**TENDER FOR THE DESIGN, CONSTRUCTION, AND MANAGEMENT OF THE MALAYSIA  
PAVILION AT THE MOBILE WORLD CONGRESS (MWC) 2025 IN BARCELONA**

**Tender No: MCMC/IAD/RMAD(01)/MWC\_2025/TC/10/24(09)**

**Questions & Answers**

9 40.6.2.Pavilion Site Location: Unit7G52 and Unit7H51, Hall 7. Refer link <https://gsma.expocad.com/Events/25mwcb/index.html> for the exhibition Hall 7 site location and floor plan.

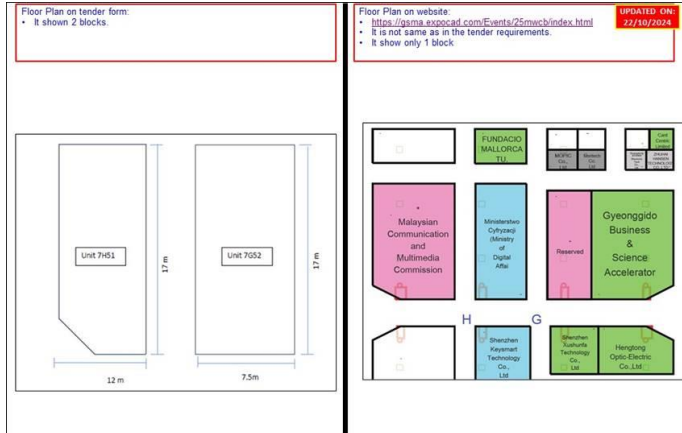
- The floor plan given in attached tender is not same with the floor plan on the link above. Can you advise which are the correct floor plan?

MCMC is currently finalizing the pavilion space with the organizer. For tender submission, kindly use the floor plan as provided in Appendix J.

**APPENDIX G**

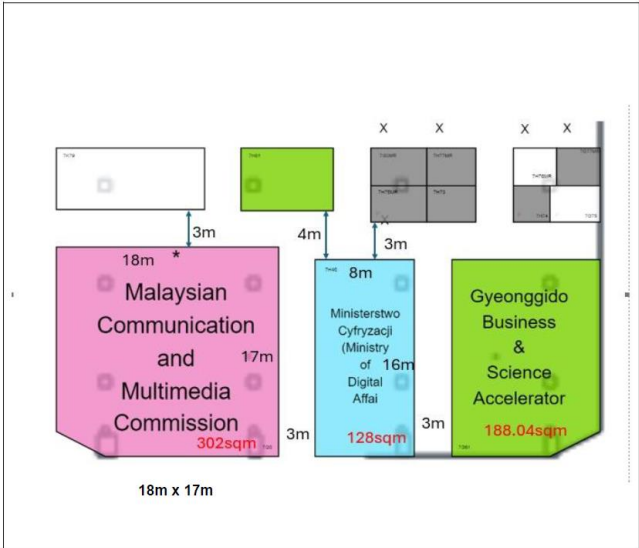
28 As we are not familiar with the tender submission, are we have to list down all paragraphs or subparagraphs in Section 5 like in attached? Can you please confirm?

Yes. Attached documents sample is the right format for Appendix G: STATEMENT OF COMPLIANCE TO THE TERMS AND CONDITIONS OF SCOPE OF WORK AND SPECIFICATION. However, please ensure to put remarks of annexure or note where applicable.
